**AGENDA
TOWN OF PITTSFORD
PLANNING BOARD
JANUARY 13, 2025**

**TOWN OF PITTSFORD
PLANNING BOARD
RESOLUTION
300 Tobey Village Road (Pittsford Oaks)
Preliminary Site Plan & Preliminary/Final Subdivision
Tax Parcels #163.02-1-24.111, 163.02-1-23.1, 163.02-1-36
Tobey PUD Parcels #8, 12, 7**

Re: Letter of Intent
Warfle Subdivision
74 East Park Road, Town of Pittsford, NY

TOWN OF PITTSFORD
DEVELOPMENT REVIEW COMMITTEE – Planning Comments
For Planning Board Meeting 1/13/25

DRAWING TITLE:
Site Plan

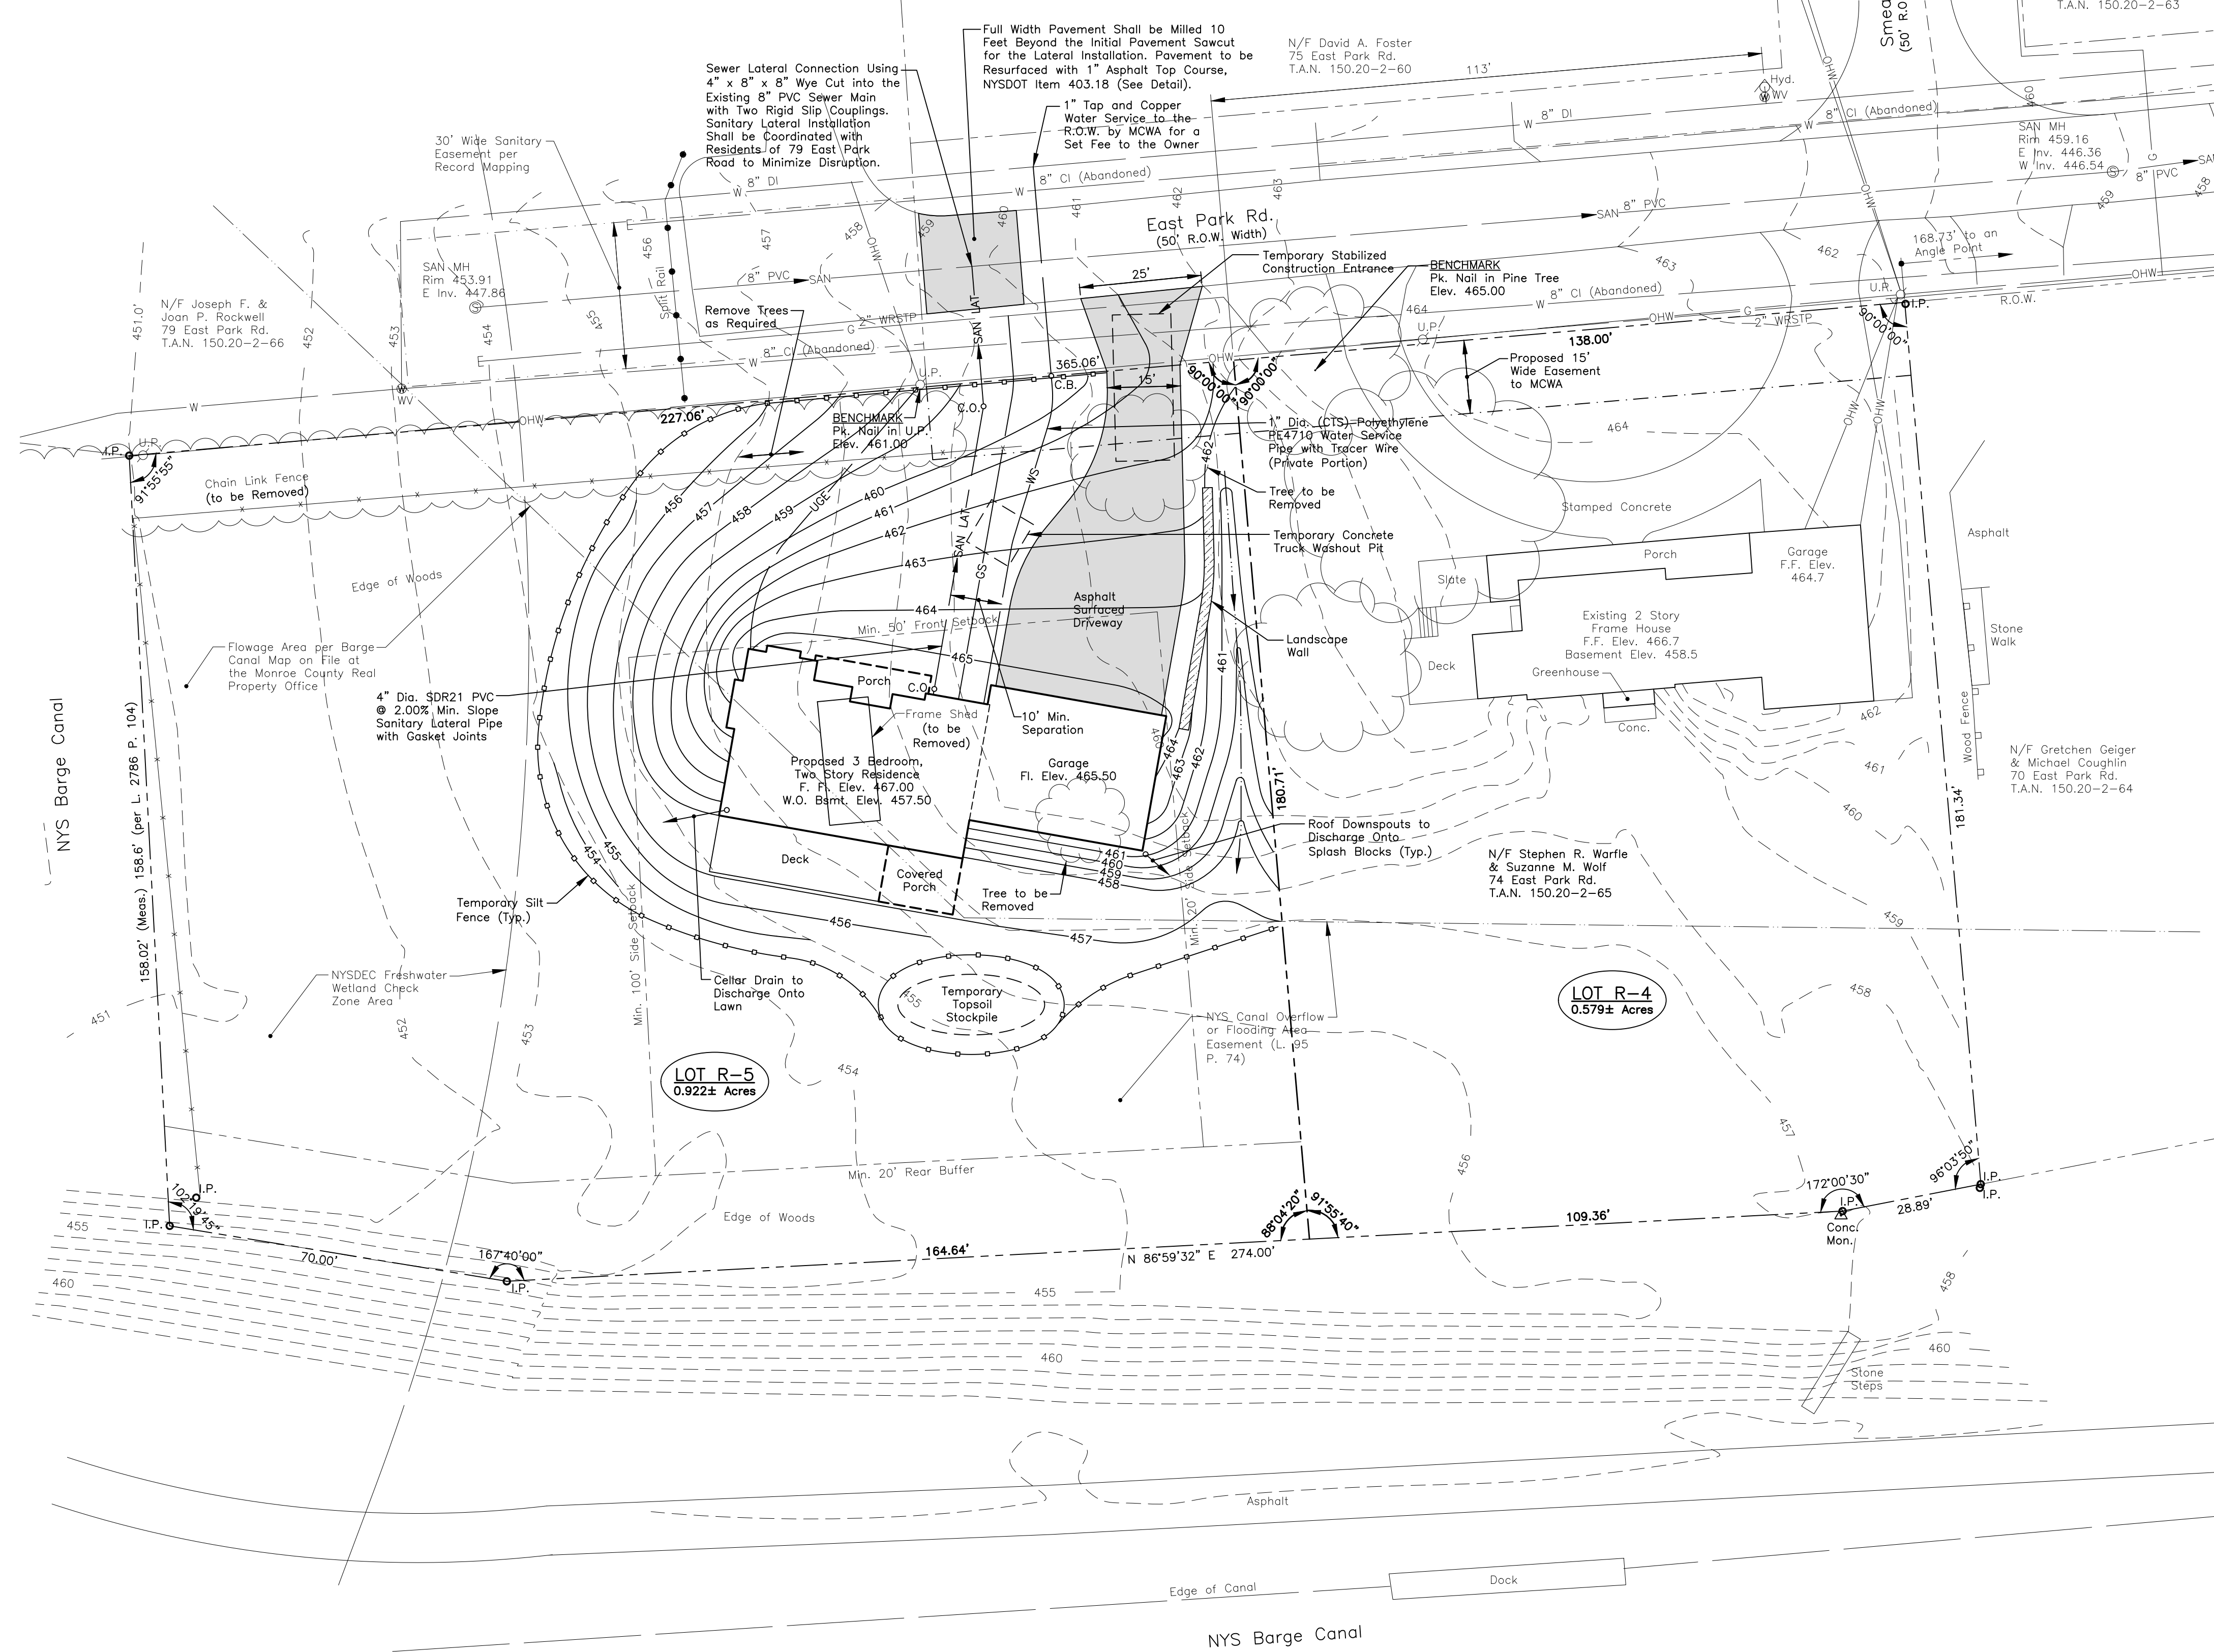
7. Please explain the intent of the proposed Monroe County Water Authority easement. If the easement is not required by MCWA, please remove it from the subdivision plans, as there is existing watermain on the north side of East Park Road. (DPW)

8. The Planning Board has previously required pedestrian access easements along road frontages as part of the subdivision review process. Please include a 15-foot-wide sidewalk/trail easement along the frontage of the entirety of the parcels, extending from the eastern property line at 70/74 East Park Road to the western property line of the proposed vacant lot (78 East Park Road). While at this time there are no plans for a sidewalk or trail in this location, one or both may become necessary in the future. (DPW)

12. At the southwest corner of the proposed home, a cellar drain discharge pipe is depicted. Please identify size and type of pipe material, and proposed slope of this pipe on the plan. Also, please identify if this will be a sump pump discharge or a gravity drain from the basement/foundation? Is it possible to direct this drainage to a subsurface drywell or a splash block? (TRE)
13. There are a couple areas of steep slopes on the west side of the proposed house and south of the proposed garage. Is it possible to lower the home and increase the fill used for grading to reduce the amount of these steeper slopes? (TRE)
